Saint Ignatius' College - s4.55 Modification to SSD 7140

DECEMBER 2019

Proposed Modifications

REVISED MASTERPLAN PRECINCT DEVELOPMENTS

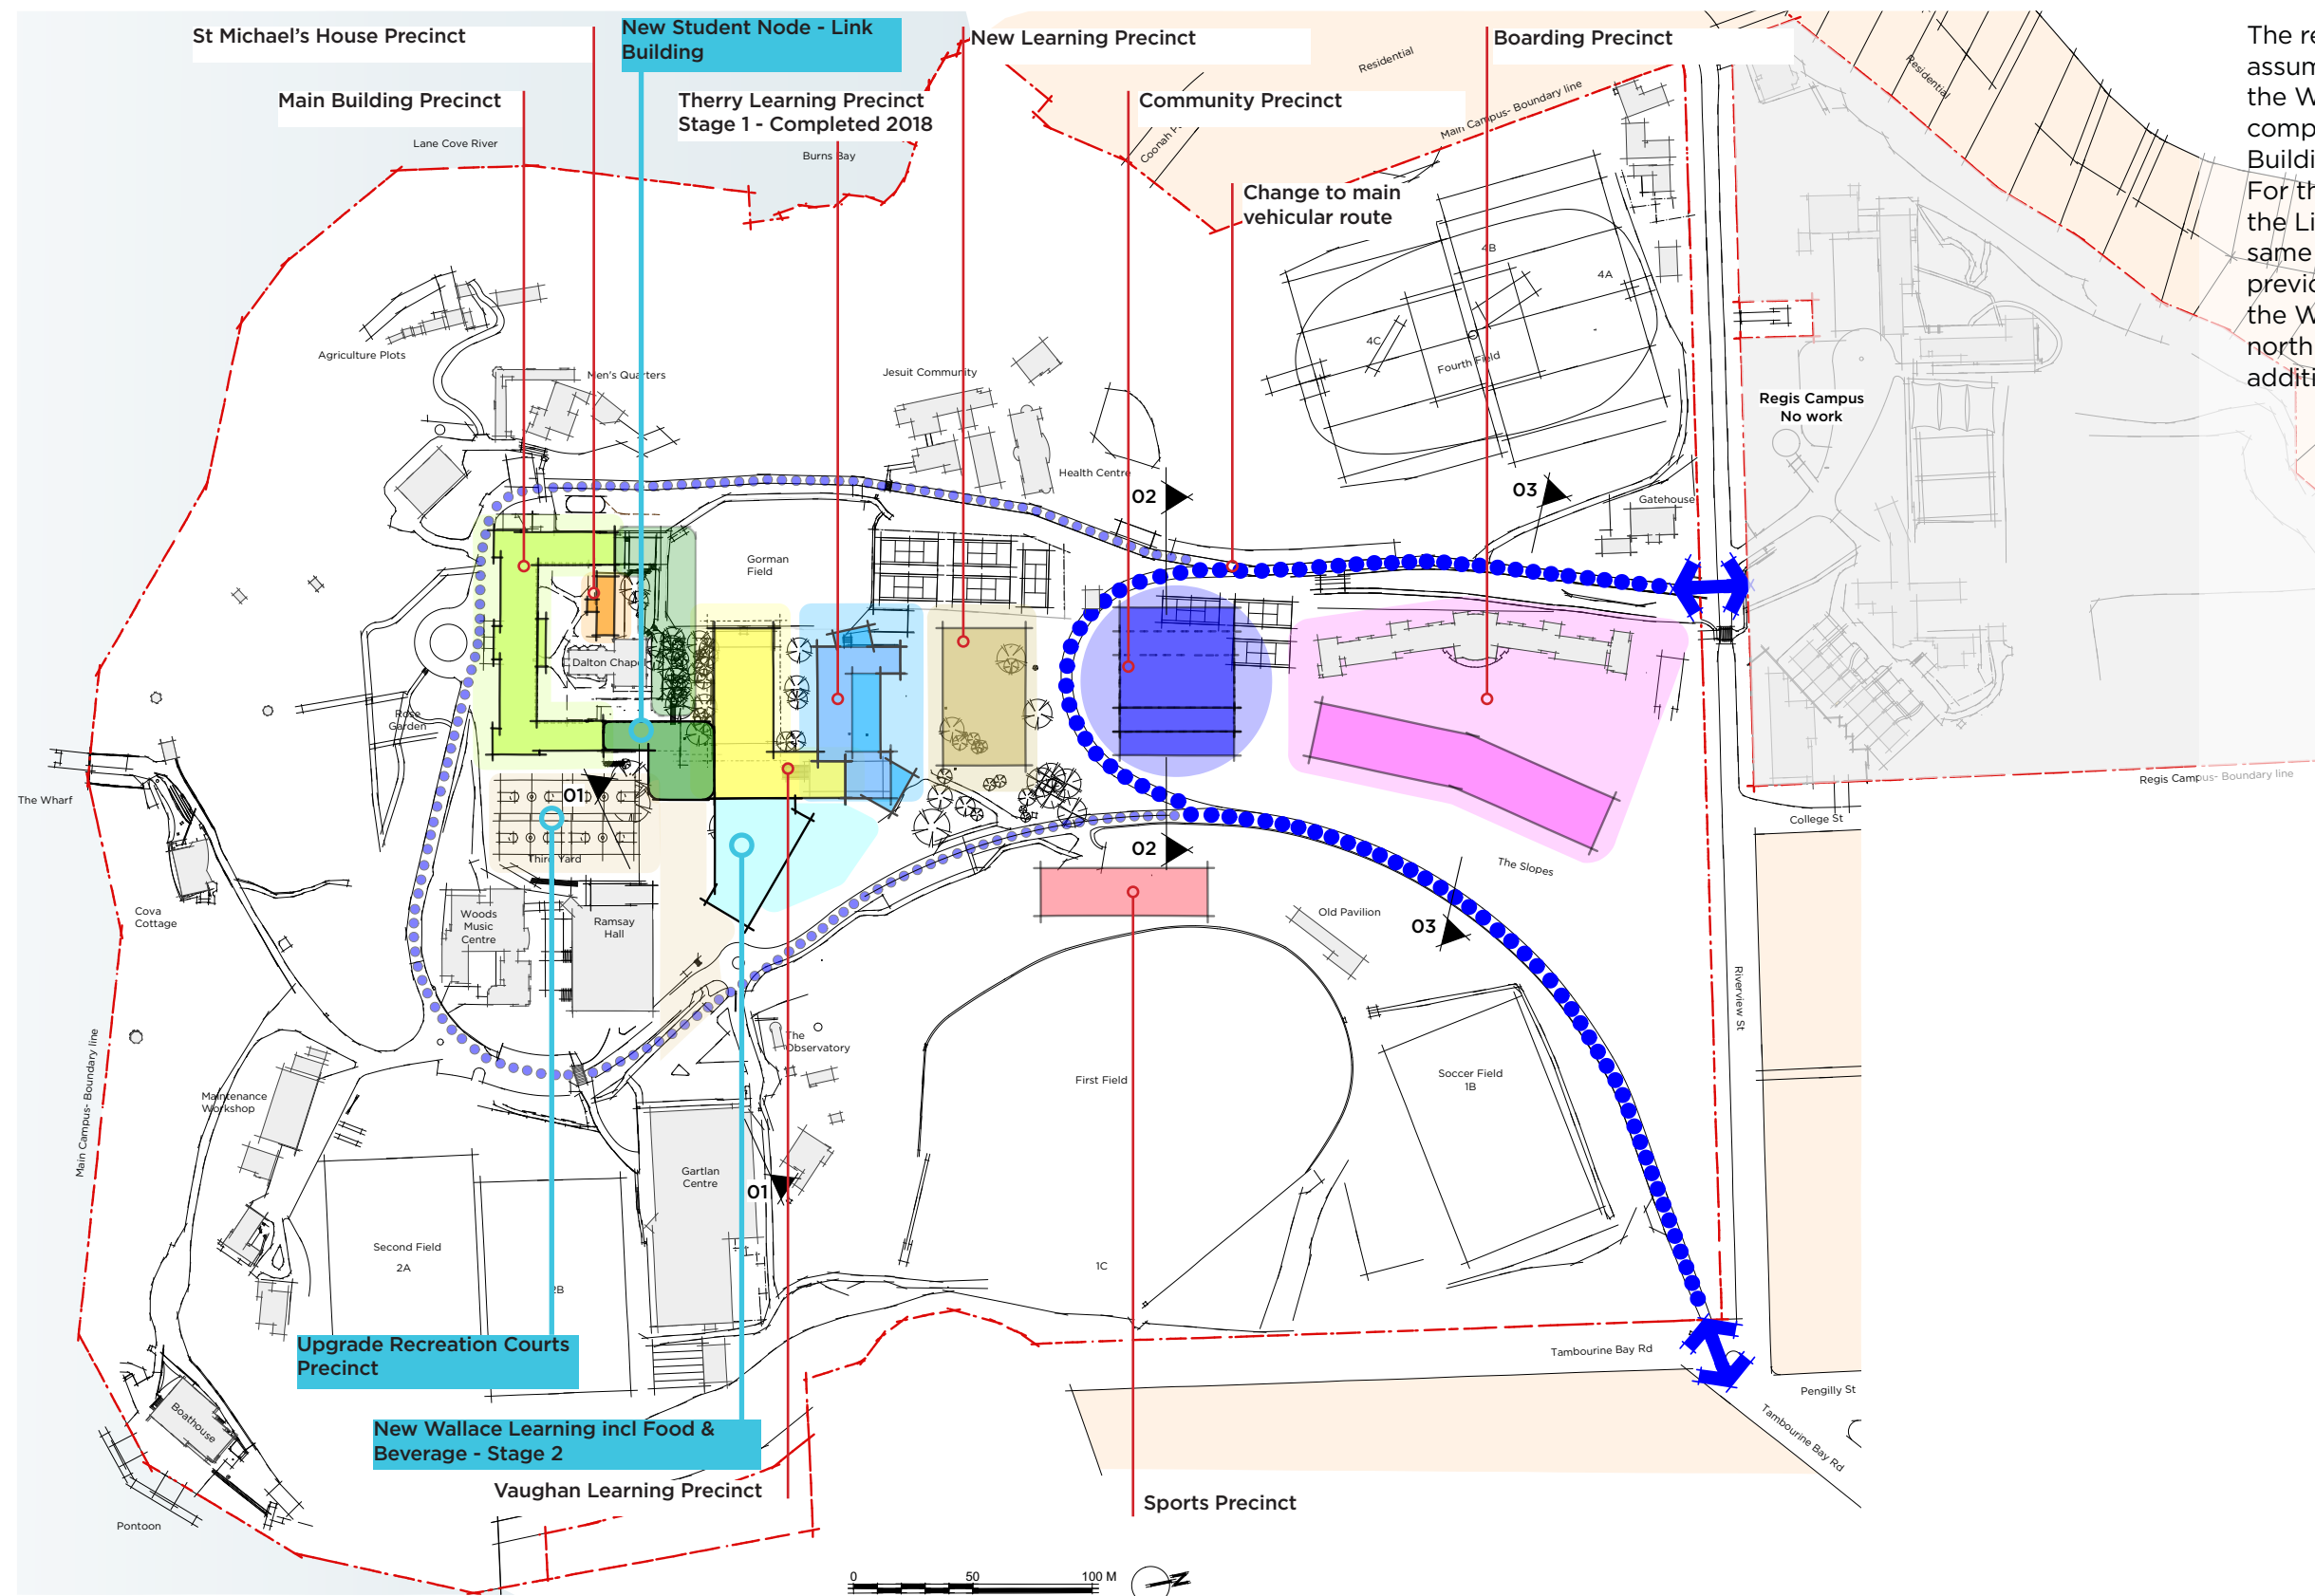
The revised precinct proposals assume the same break up of the Wallace Precinct into two components being the Link Building and the Wallace Building. For the modification it assumes the Link Building remains the same in height and areas as previously shown and that the Wallace Building is shifted north with greater footprint and additional area.

REVISED STAGES | NEW STUDENT NODE - LINK BUILDING

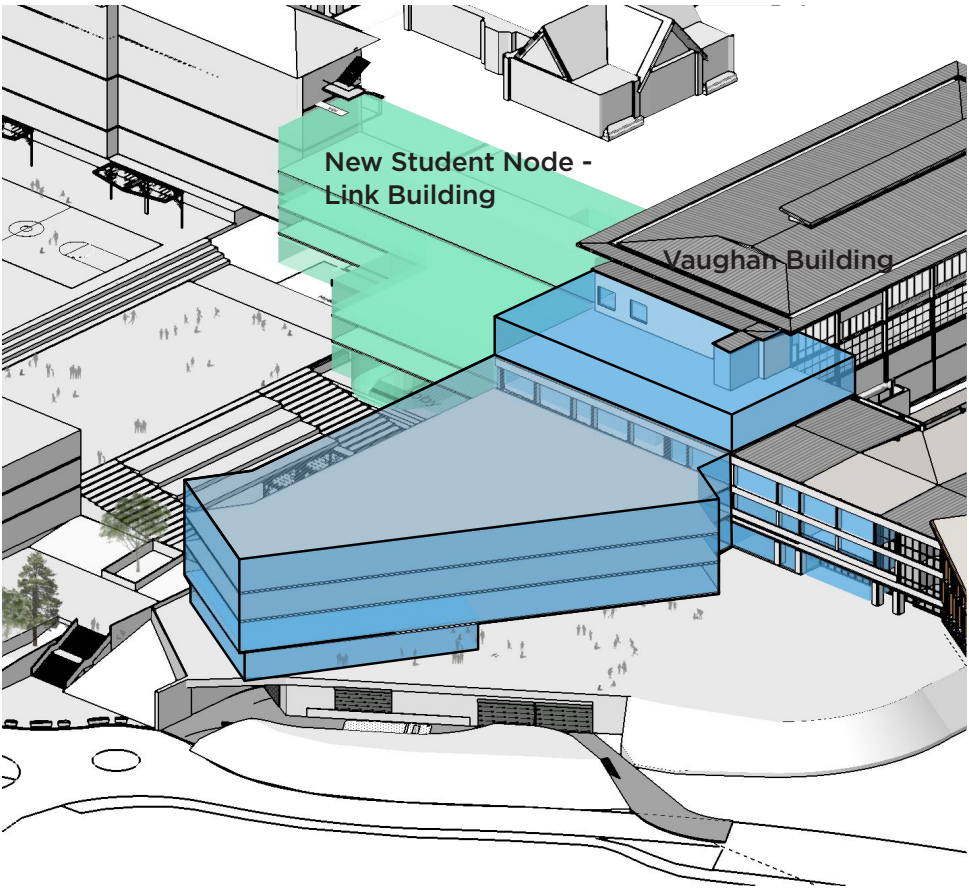
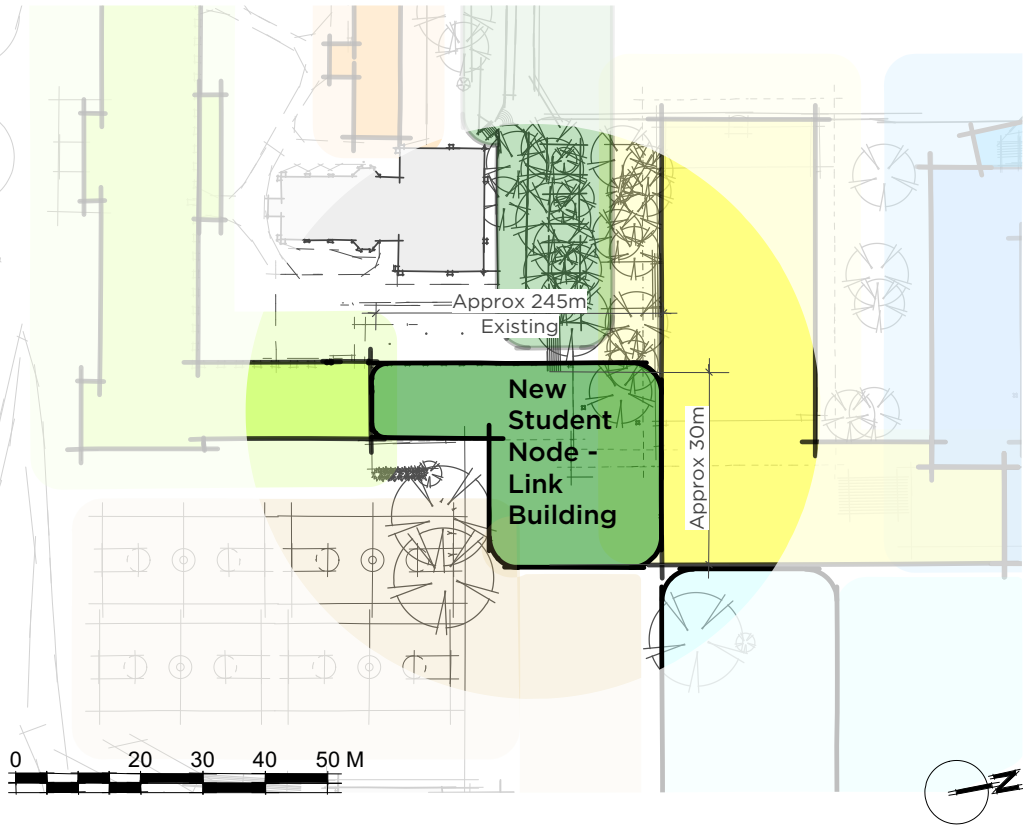
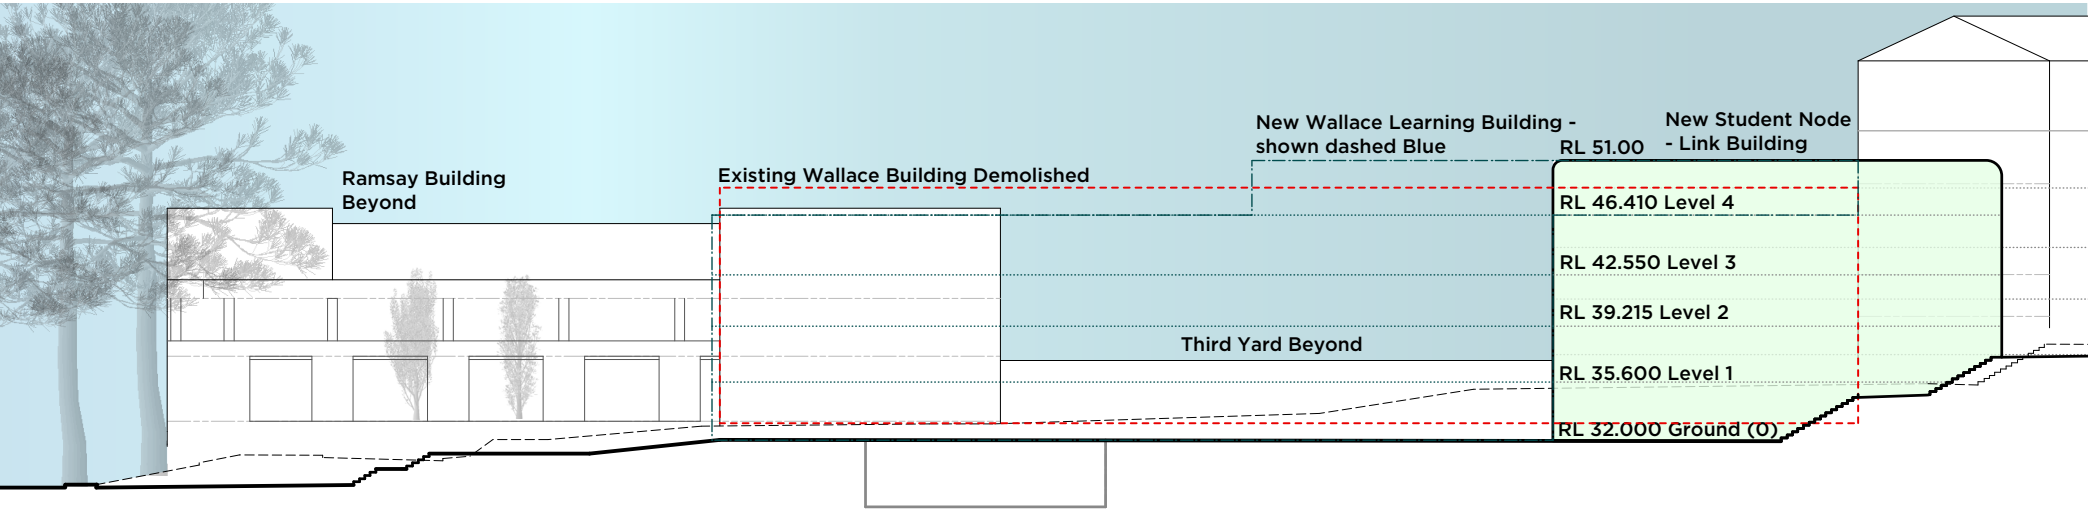
- New Student Node - Link building**
- GFA = 3,800m² (same area previously approved)
 - Number of Levels = 5
 - Building height = RL 51.00

Demolish the existing Administration building and replace with new facility of greater footprint in same location between existing Main & Vaughan buildings. Height of new building at 5 levels the same as approved scheme. The new building provides a centralised location for student and staff support services and an arrival point to the Learning Precinct.

REVISED STAGES | NEW WALLACE LEARNING BUILDING

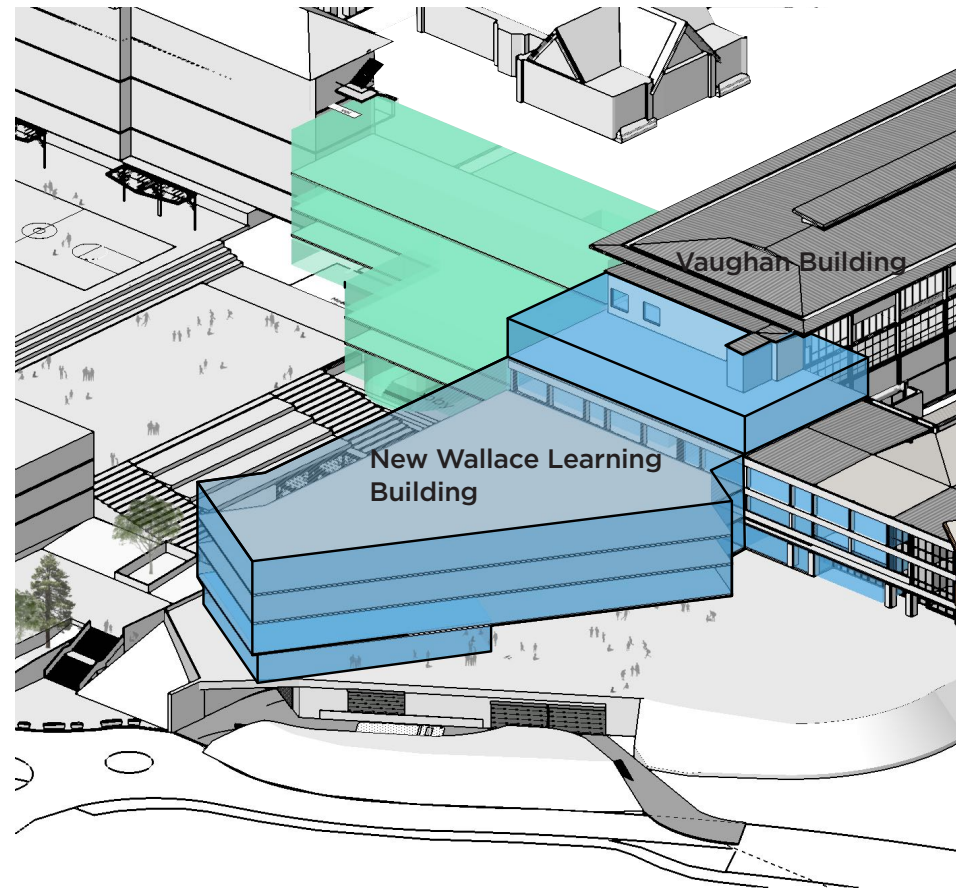
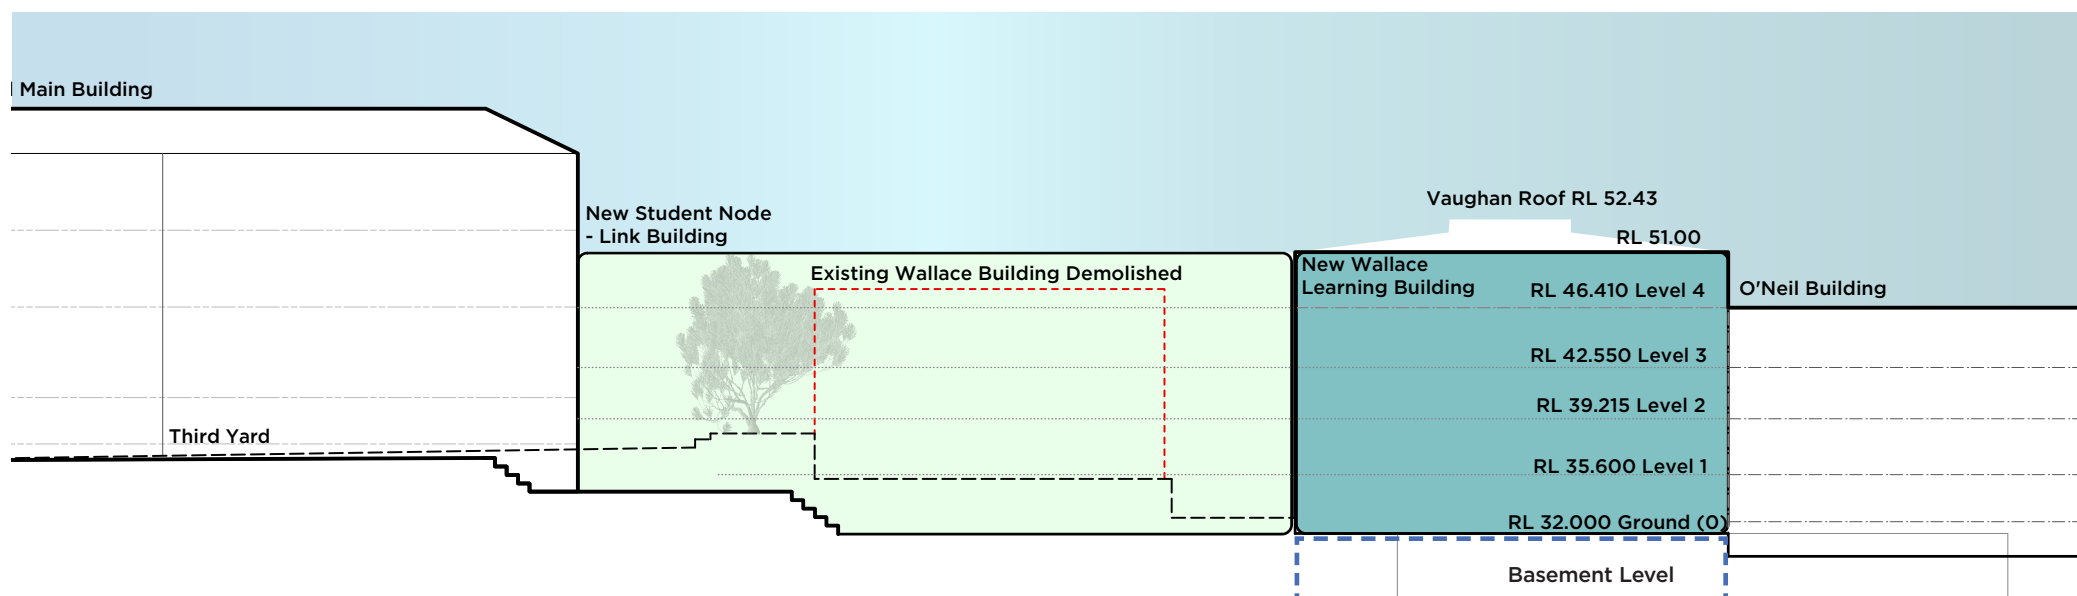
- GFA = 5,290m² (Additional 1,090m² than previously approved)
- Basement of 1,000m² not included in GFA
- Number of Levels = 5
- Top of Building = RL 51.00

Demolish the existing Wallace and replace with new facility of greater footprint located 30m north attached to existing Vaughan building. Height of new building at 5 levels will be 1 level higher than the approved scheme which will equate to the existing top floor level of the existing Vaughan Building. The new building will provide improved and diverse learning opportunities for Science, Technology, Engineering, Mathematics and PDHPE as a STEMP facility. Ground level will accommodate a C.O.L.A and Canteen (Food & Beverage) with servicing by loading area on basement level.
